Sydney Metro Design
Review Panel
Letter of Design Excellence Pitt
Street South Over Station
Development

Pitt Street North Over Station Development – Design Excellence

Advice and Actions Record – 14-15 September 2020

The Pitt Street ISD project team presented DRP presentation 13 which covered the responses to submissions to OSD North, and the facade depth of OSD South.

June 21 | 2.00pm

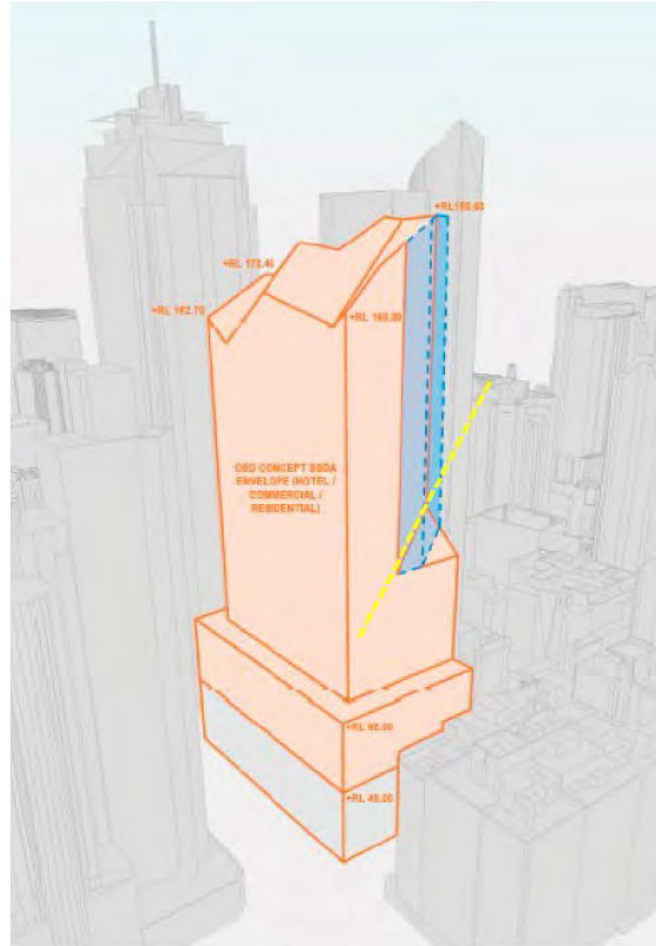
- The Panel notes the shadows cast over Hyde Park by the Pitt Street development remain within the footprint of shadow already cast by existing development at 201 Elizabeth Street and an alternative and smaller built form envelope proposed for 201 Elizabeth St (which is currently not intended to proceed).
- The Panel defers to DPIE for compliance decisions relating to overshadowing of surrounding residences.

12.01	OSD North	Built Form	15/09/2020	DRP 13 Presenation	Hyde Park solar access The Panel notes the shadows cast over Hyde park by the Pitt Street development remain within the footprint of shadow already cast by existing development at 201 Elizabeth street and an alternative and smaller built form envelope proposed for 201 Elizabeth St (which is currently not intended to proceed).	N/A			Closed

During the solar & overshadowing analysis period however, the revised & approved Stage 01 Envelope for 201 Elizabeth Street has resulted in our original SEARS envelope creating additional overshadowing to Hyde Park between 1.30pm – 2.00pm, June 21st

Maximise solar access to Hyde Park

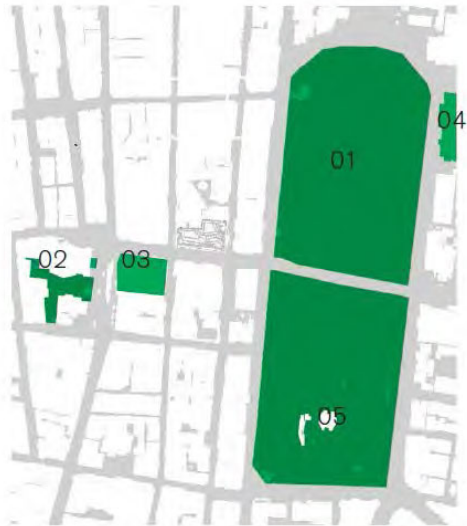
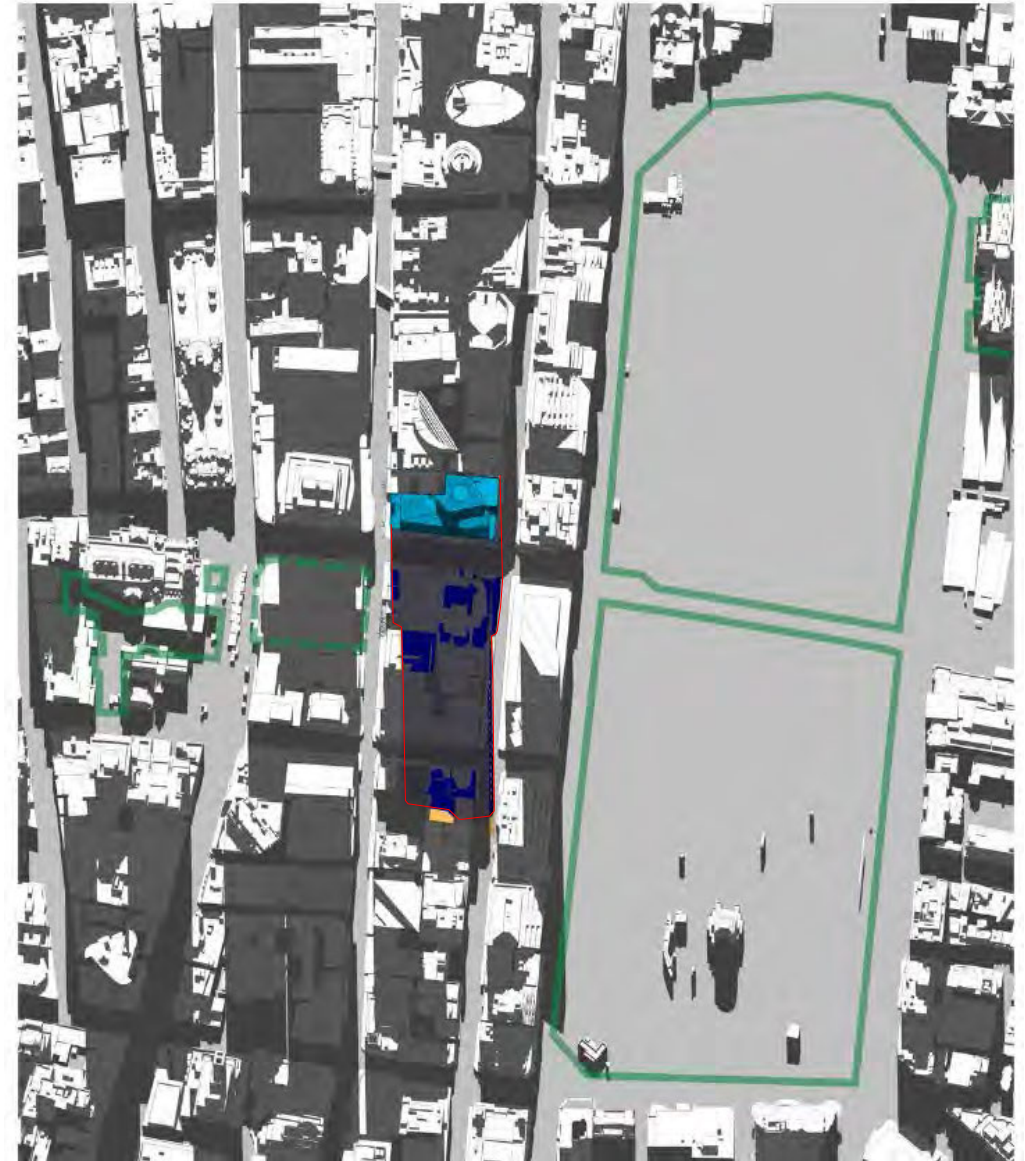
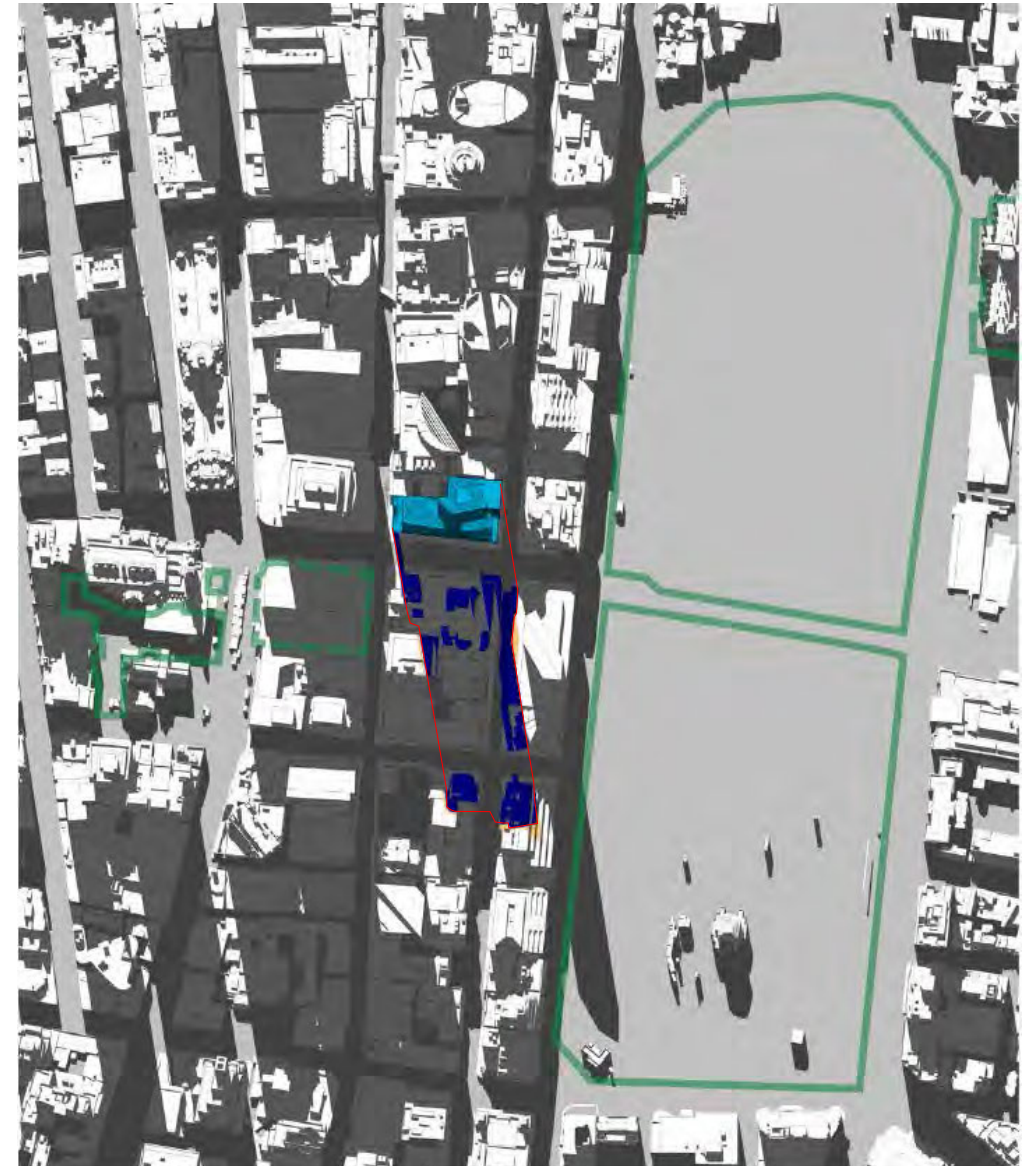
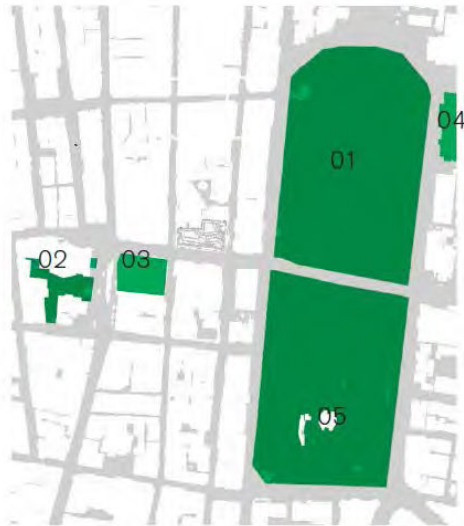
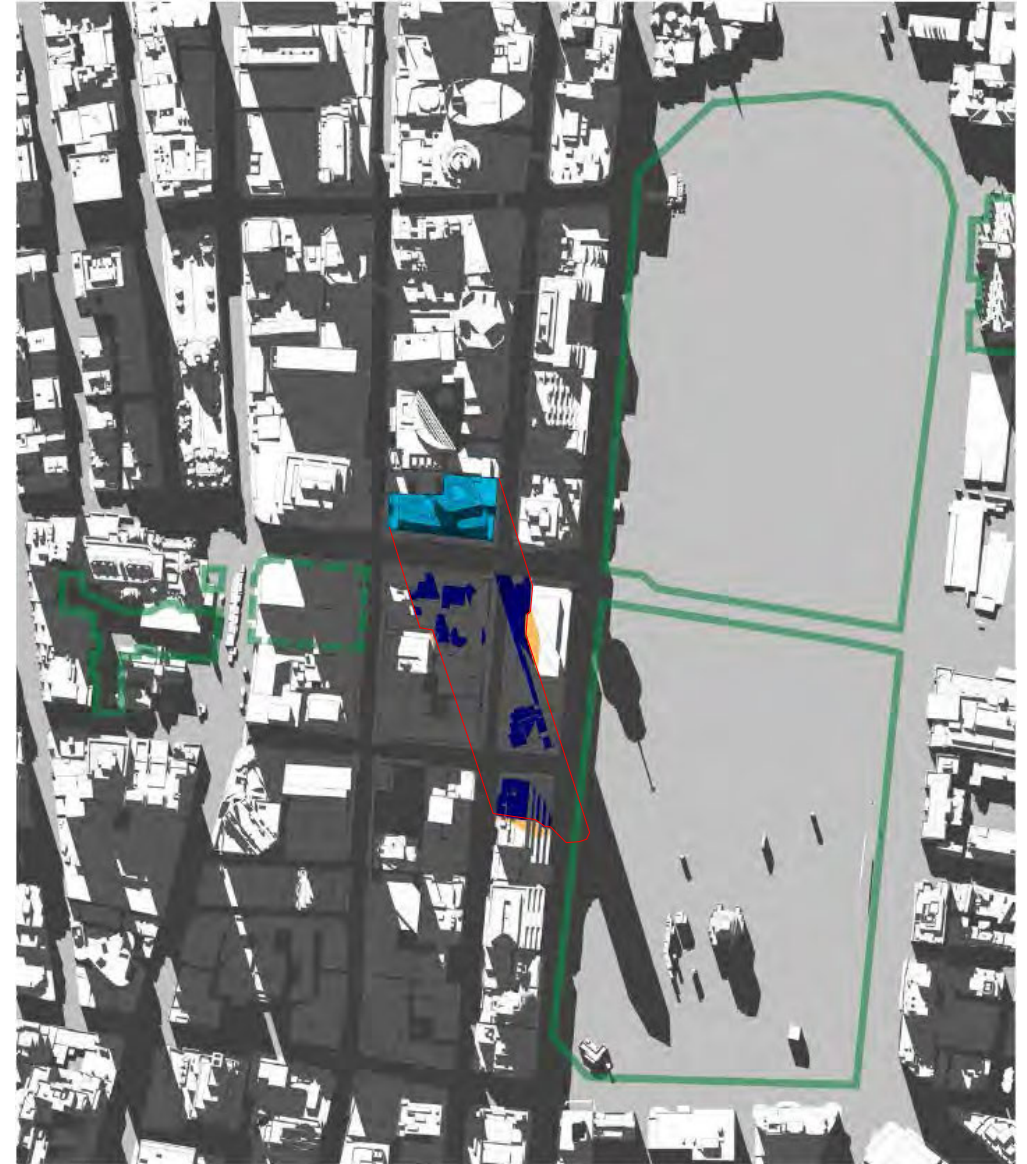
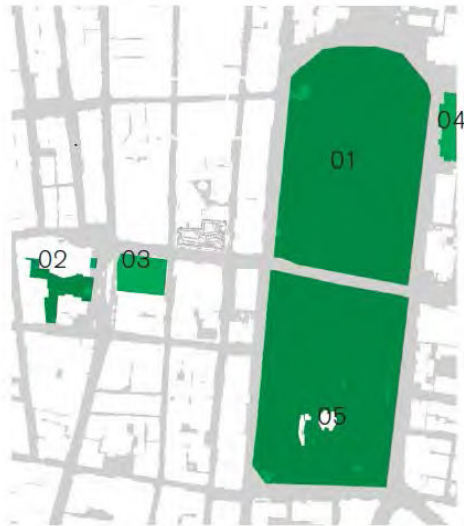
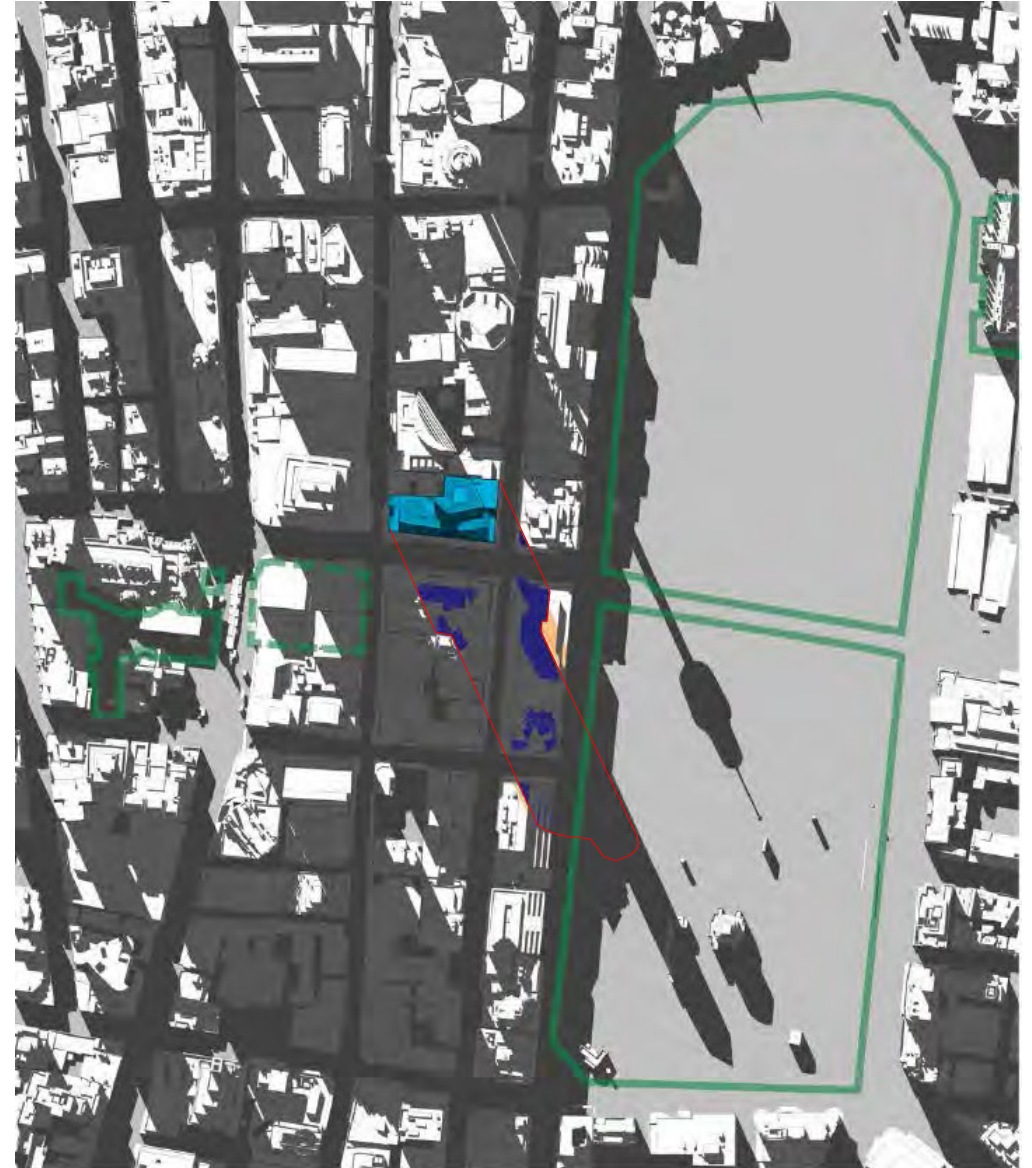
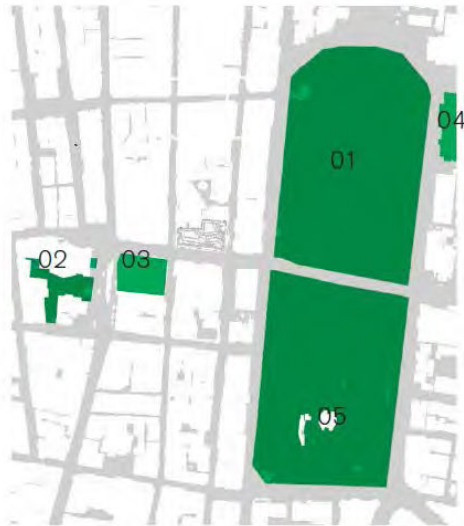
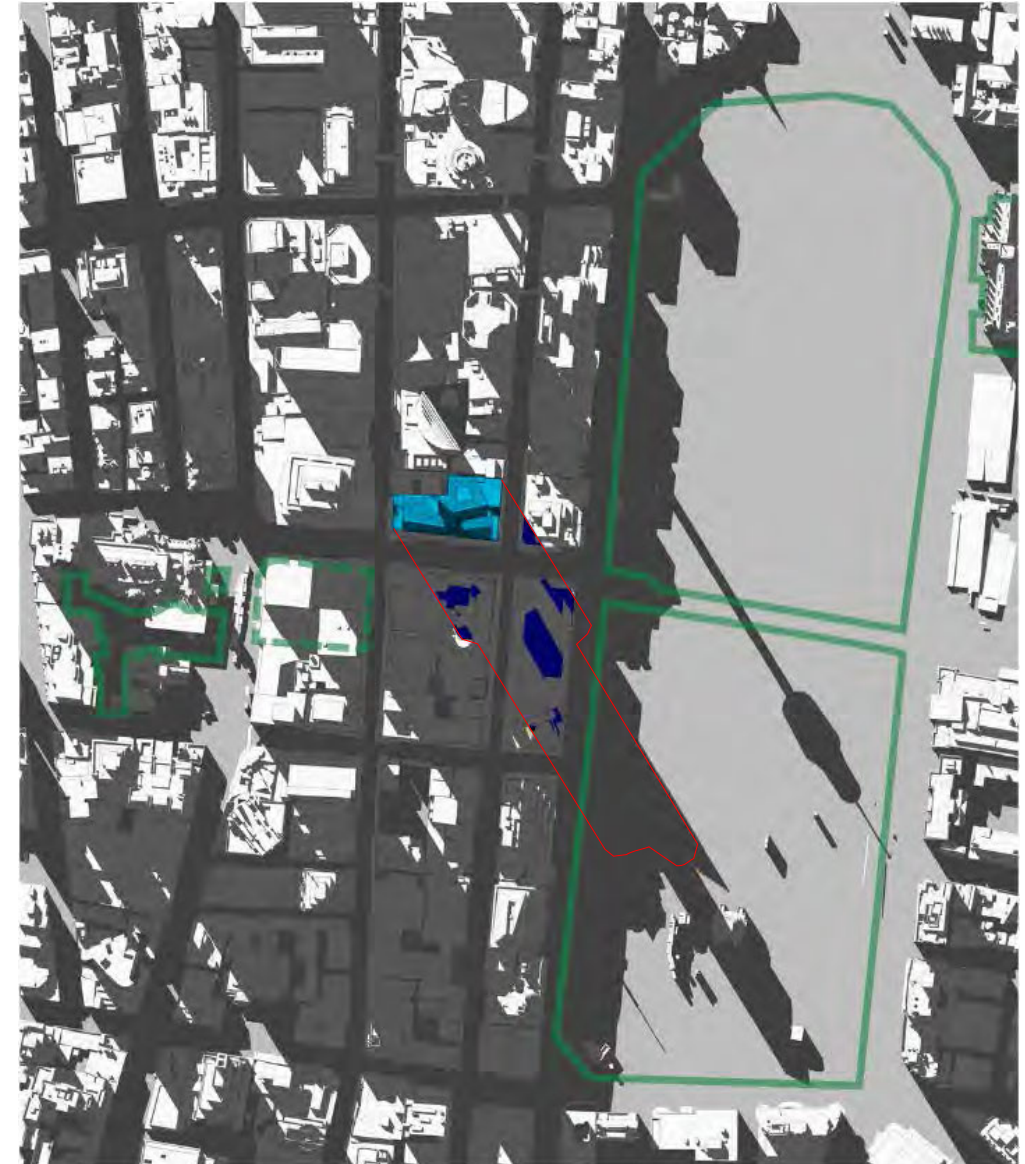
Review the distribution of floor space to minimise external impacts and satisfy the following Design Guidelines requirements:

*(6.b) Maximise solar access to the public domain, through responding to the reduced shadow cast by the **redevelopment of 201 Elizabeth Street on Hyde Park on June 21st, between 12pm and 2pm** - Sydney Metro preliminary design work propose an angled offset of the north eastern corner of 4.1m to achieve this outcome.*

The proposed envelopes overshadowing requirements are governed by the Hyde Park West 3 Sun Access Plane, subject to Clause 6.17 of the LEP2012 ensuring no additional overshadowing to Hyde Park.
